Recall Service Bulletin RSB21-330-001

DATE: 7/8/2021

APPLIES TO: This service bulletin applies to 2009 through 2021 model year, Gladiator, MetroStar and MetroStar X model emergency response chassis cabs built between June 4, 2009 and November 11, 2020.

CONDITION: Fire pump fails to shift into pump mode.

FIG 6.1

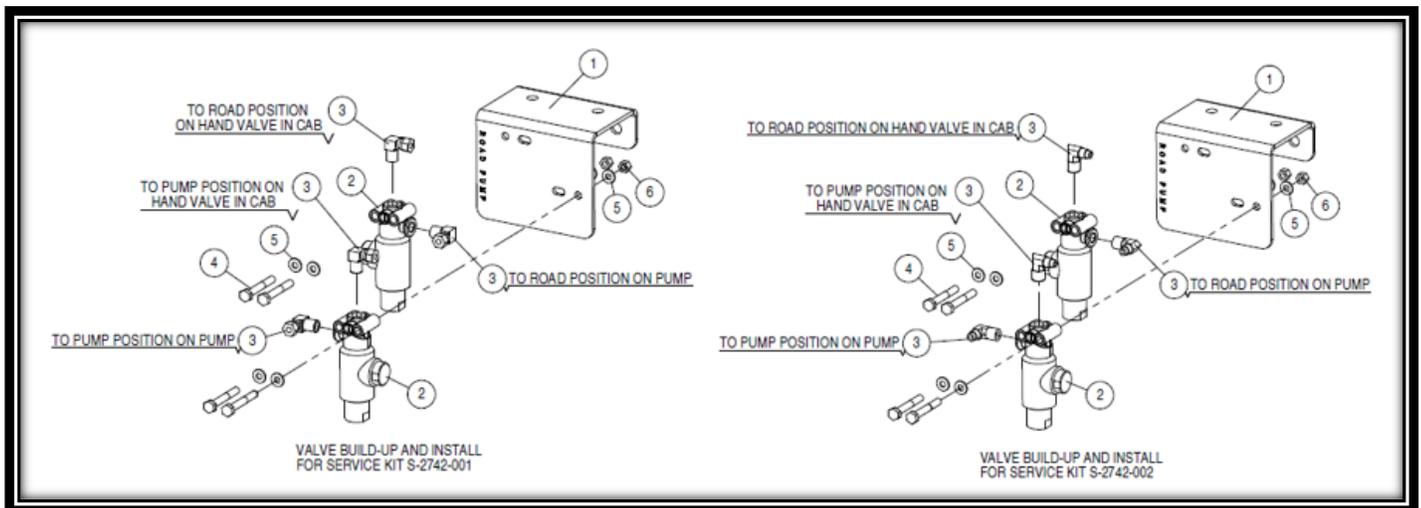
8. Assemble the solenoid valve assemblies by using solenoid part number 0918-MM5-012 (Item 2). Install 90° degree elbows in the supply and delivery ports of the solenoid valve.

- a. For nylon air lines, use fitting 0716-MM5-B02 (Item 3 in left assembly).
- b. For wire braid air lines, use fitting 0716-MM5-BB0 (Item 3 in right assembly).

13. Attach the solenoids to the bracket using 05180225H8Y (Item 4), 05FWSAE8Y (Item 5) and 0518LN8Y (Item 6). Torque bolts to 21 lb-ft. Refer to Fig 6.1.

FIG 7.1

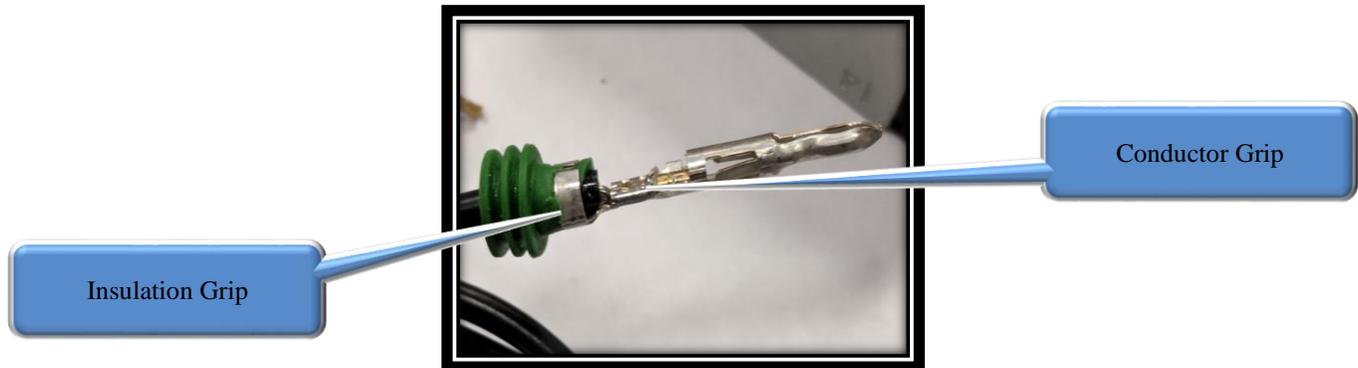
10. Insert 12010293 cable seal on to all wires during the crimping of 12124582 terminal pin on all wires. Inspect to ensure terminal is straight and not bent. Ensure the wire's conductors are crimped to the conductor grip of the terminal while the cable seal is crimped along with the wire's insulation grip. Refer to FIG. 7.1.

FIG 8.1

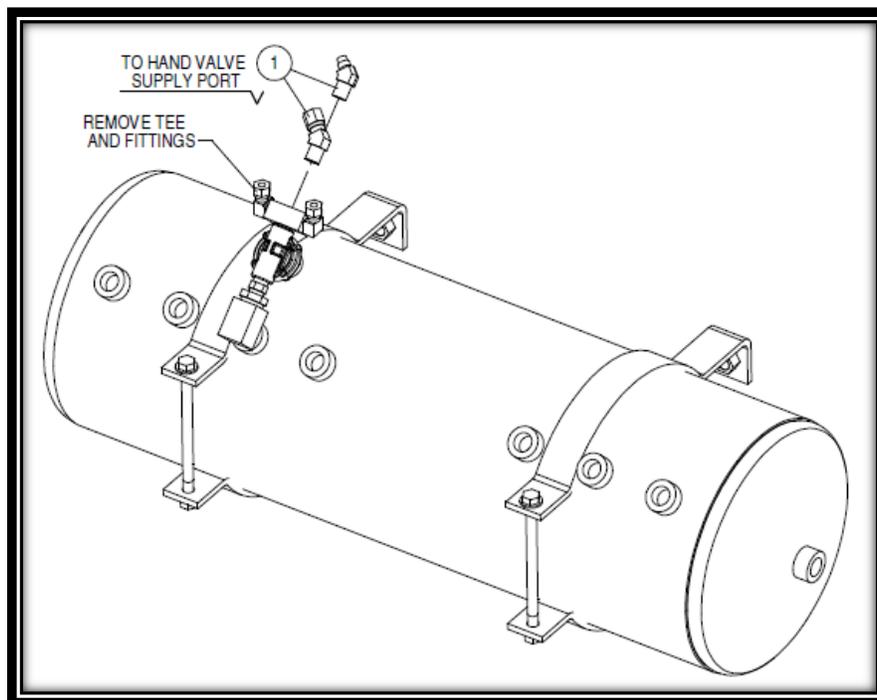
15. Locate the primary air tank. Identify the pressure protection valve with the air lines that route to the pump shift hand valve in the cab and the solenoid supply port. Remove the branch tee and fittings from the end of the pressure protection valve and replace it with 45° elbow fitting. Refer to Fig 8.1.

- a. For nylon air lines use fitting 0716-MM5-C02 (Item 1).
- b. For wire braid air lines use fitting 0716-MM5-DD02 (Item 1).

FIG 9.1

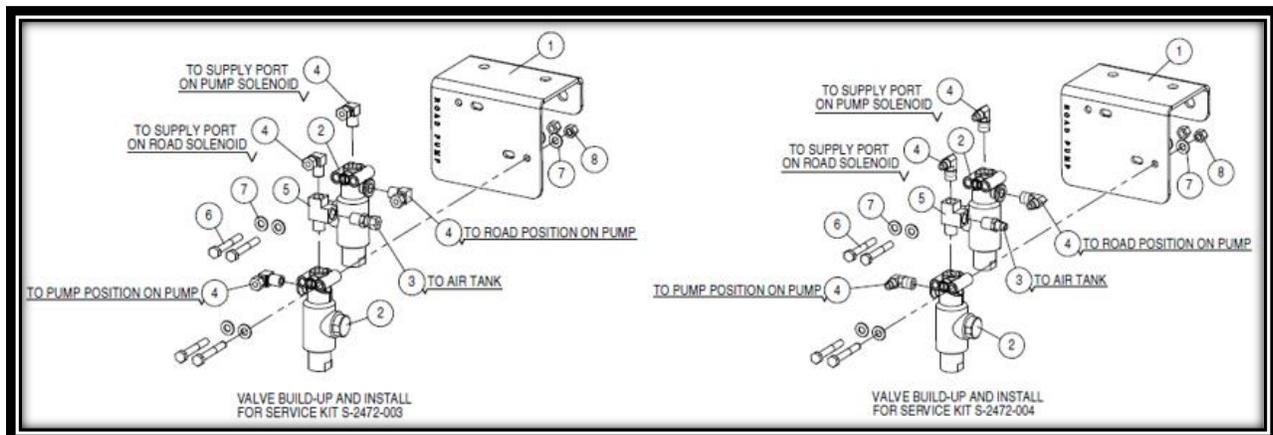
21. Assemble the solenoid valve assemblies by using solenoid part number 0918-MM5-012 (Item 2). Install 90° degree elbows in the delivery ports of the solenoid valve. Install street tee 0716-MM5-R02 (Item 5) into supply port of the one solenoid. Install a 90° elbow into the top port of the street tee and a straight fitting into to other port of the street tee. Install a 90° elbow into the supply port of the other solenoid.

- a. For nylon air lines use fitting 0716-MM5-B02 (Item 4) and 0716-MM-A02 (Item 3), referenced in the left assembly.
- b. For wire braid air lines use fitting 0716-MM5-BB03 (Item 4) and 0716-MM5-Y03 (Item 3) referenced in the right assembly.

26. Attach the solenoids to the bracket using 05180225H8Y (Item 6), 05FWSAE8Y (Item 7) and 0518LN8Y (Item 8). Torque bolts to 21 lb-ft. Refer to Fig 9.1.

FIG 10.2

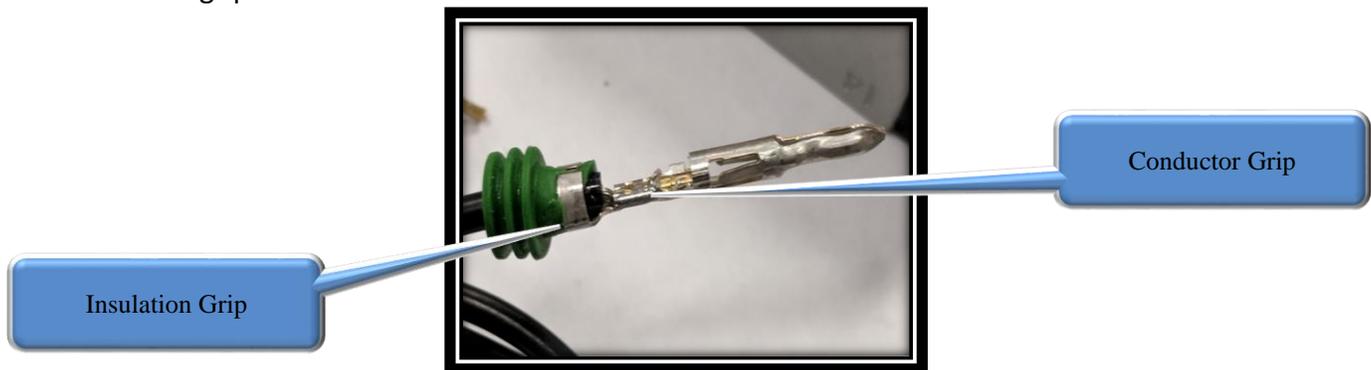
23. Insert 12010293 cable seal on to all wires during the crimping of 12124582 terminal pin on all wires. Inspect to ensure terminal is straight and not bent. Ensure the wire's conductors are crimped to the conductor grip of the terminal while the cable seal is crimped along with the wire's insulation grip. Refer to FIG. 10.2

FIG 11.1

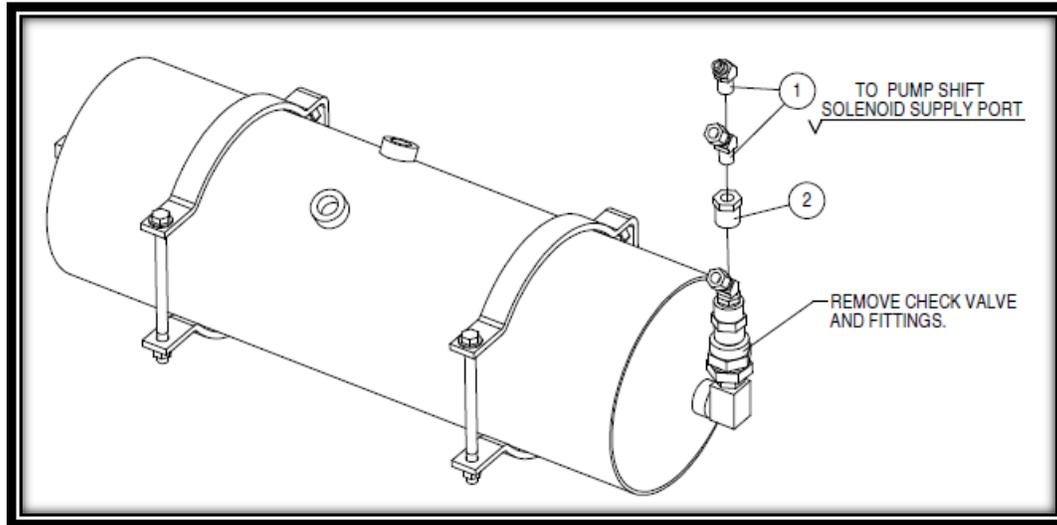
30. If the pump shift solenoid is supplied from an auxiliary air tank, remove the fitting, check valve and nipple fittings from the air tank. Install 0716-MM5-J05 bushing (Item 2) into the elbow on the air tank. Install a 45° elbow fitting into the bushing. Refer to FIG 11.1. Install an air line from the air tank to the straight fitting on the supply port of the new solenoid. Run an air line between the supply port fittings.

- a. For nylon air lines use fitting 0716-MM5-C02 (Item 1)

- b. For wire braid air lines use fitting 0716-MM5-DD02 (Item 1)
